Melbourne Metro Rail Project Inquiry and Advisory Committee

Expert Evidence Submission
Trees, Parks and Public Open Space
An ecological, cultural and economic
assessment

Ian Shears – Manager, Urban
Sustainability
12 August 2016

Figure 1 Trees expected to be impacted upon in the north-east corner of Fawkner Park

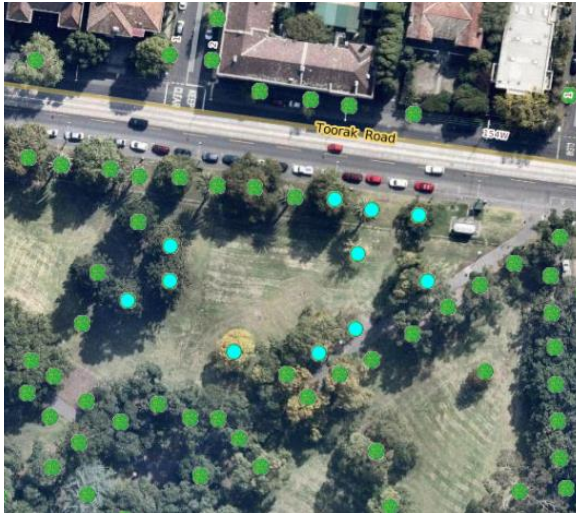
Location	No. trees that will be impacted as reviewed by CoM	Amenity value of trees identified in assessment by CoM	Additional trees that may be impacted due to works
Fawkner Park – Emergency Access Shaft N-E Corner	8	\$283,177.29	4

A total of 8 trees would potentially require removal in this section of Fawkner Park, at an amenity replacement cost of \$283,177.

For this site it was noted that there was an impact upon Tree F238 (*Araucaria bidwillii* Bunya Bunya Pine), whilst there was no impact recorded upon any other trees that are in close proximity.

Fawkner Park is a highly used and valued regional open space. The Fawkner Park Masterplan identifies one of the outstanding values of the park as the landscape character with simple open character of the park and long straight avenues lined with trees defining characteristics. The siting of the EAS in Fawkner Park will be dominating and out of place in the setting of the park and in conflict with the established character. The insertion of the EAS will result in a permanent loss of this valuable open space, loss of visual and landscape amenity, loss of mature trees and likely damage to further trees. The use of Fawkner Park as a location for the EAS is not supported and it is recommended that an alternative location outside of Fawkner Park must be identified.

Figure 3 Trees expected to be impacted upon in the Parkville Station precinct

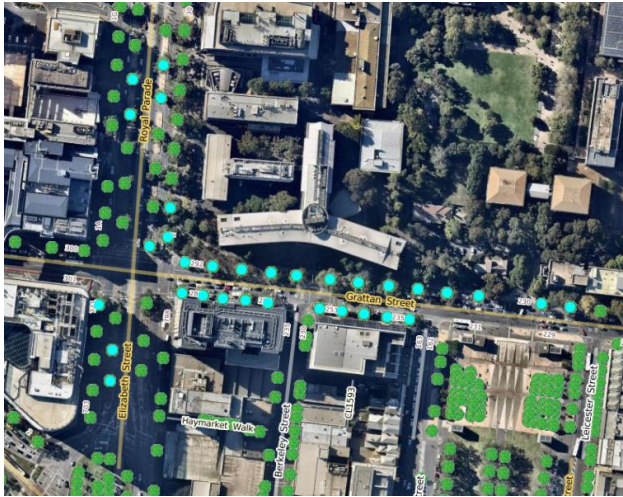
The EPRs seek to avoid tree removals where ever possible. One hundred and six trees are proposed to be removed in this precinct, which includes:

- approximately 74 trees removed within University Square
- 10 elms to be removed in Royal Parade
- 24 mature trees in Grattan Street.

It is noted that the proposed tree removals in the University Square location would be in line with future CoM planned works and are of low concern.

The most significant impact is the removal of 10 Royal Parade elms shown in the Concept Plan. It is submitted that during the final planning stage every option must be exhausted to ensure the minimum amount of trees would require removal. These trees fall within land that is included on the Victorian Heritage Register. Heritage Victoria has been contributing to the Technical Reference Group.

CH12 – To the satisfaction of Heritage Victoria and the responsible authority, replace removed elm trees in Royal Parade as part of project delivery using appropriate species and re-establish the boulevard formation.

Provide suitable soil conditions to facilitate the growth of new trees to reach the size of the existing mature trees in the boulevard.
